# SPR EA1N and EA2 PROJECTS

## DEADLINE 4 - COMMENTS ON APPLICANTS DEADLINE 3 SUBMISSIONS

Interested Party: SASES PINS Refs: 20024106 & 20024110

#### Onshore Substations Update Clarification Note [REP3-057] and Project Update Note [REP3-052].

Plate 5.2: 3D model of the updated easternmost onshore substation showing reduced footprint and building / equipment parameters

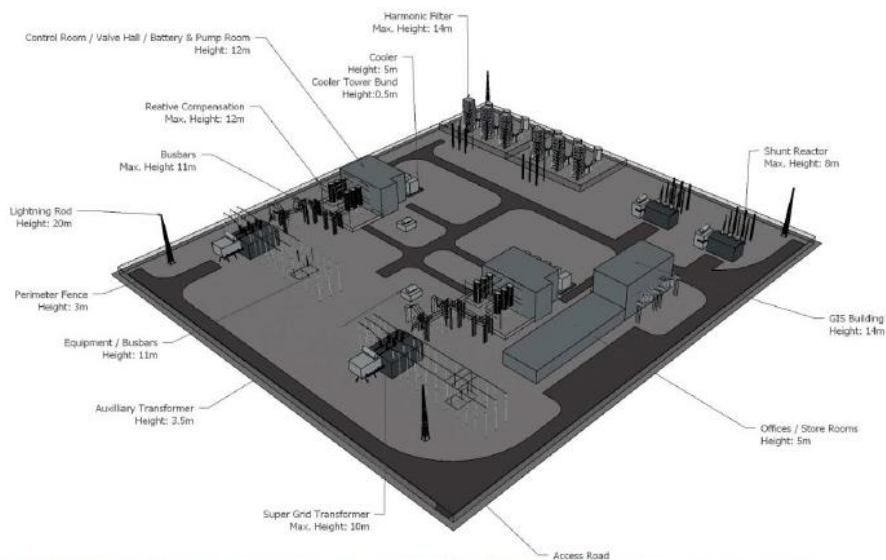
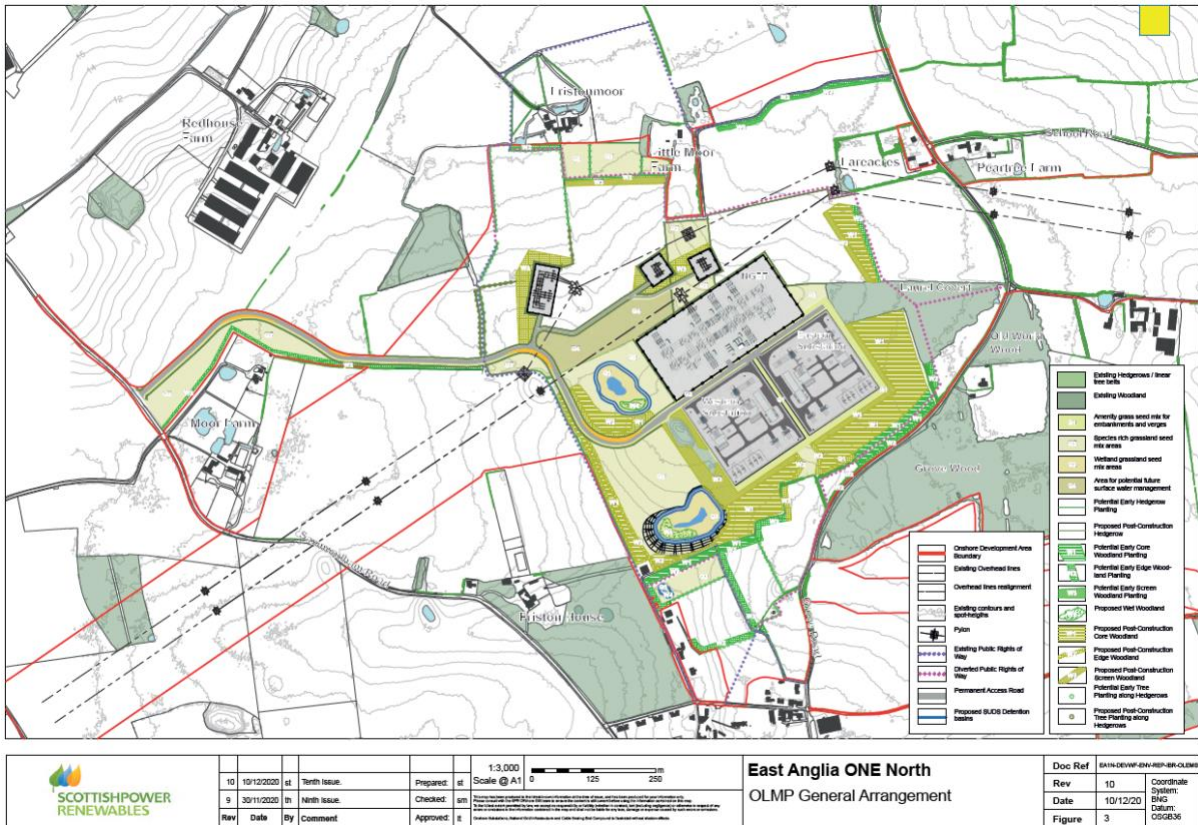
4. The 3D schematic (Plate 5.2 of [REP3-057]) and revised OLMP (Figure 3 of [REP3-030]) both show large areas of vacant substation area between the reduced sized electrical equipment. The Applicants are asked to justify why the equipment spacing is so great and why there is no reduction in the 190m dimension. It should be noticed that the orientation of the 3D schematic in plate 5.2 is different from the orientation of both the eastern and western substation shown in the OLMP.

11. Given plate 5.2 sets out the heights of more structures than set out in the DCO these heights should be specified in Part 3 of Schedule 1 - Requirements of the DCO otherwise the heights of the structures could be increased to 14 metres.

**Figure 3**

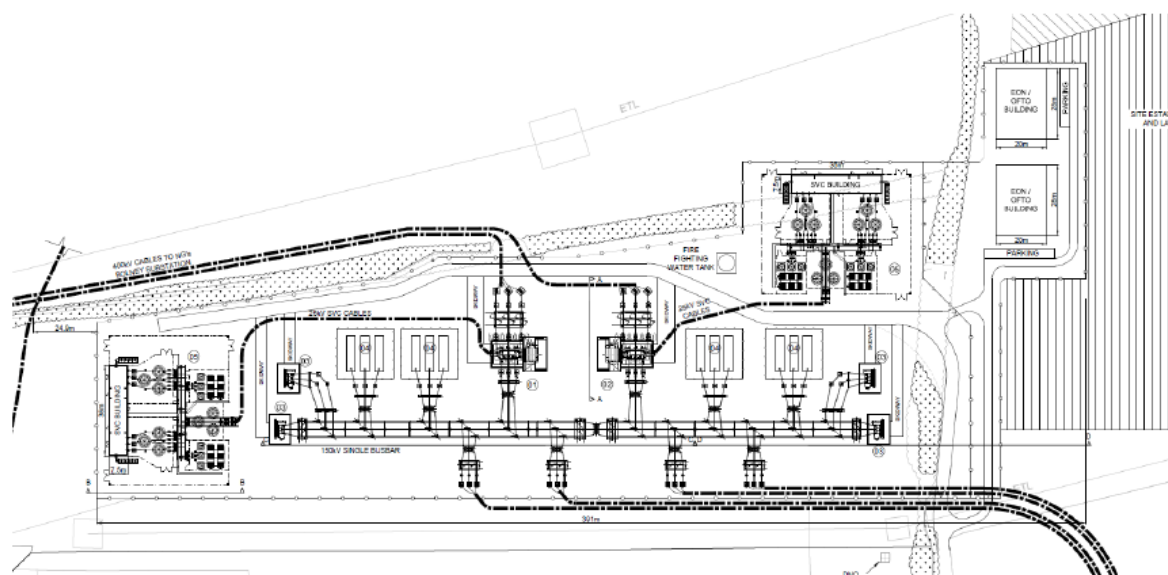
7. The reference Rampion wind farm substation design (Figure 3 on page 165 of [REP1-227]) appears to use multiple smaller Harmonic Filters in order to produce an overall reduction in height. Has this option been explored?

8. There is not thought to be any specific reason why the substation footprint has to be rectangular. The footprint of the reference Rampion wind farm substation (Figure 3 on page 165 of [REP1-227] and reproduced below) is not rectangular; rather it has been designed to fit within existing site hedgerow boundaries, so avoiding unnecessary

environmental destruction and maximum use of existing screening. Have the Applicants given consideration to this approach?
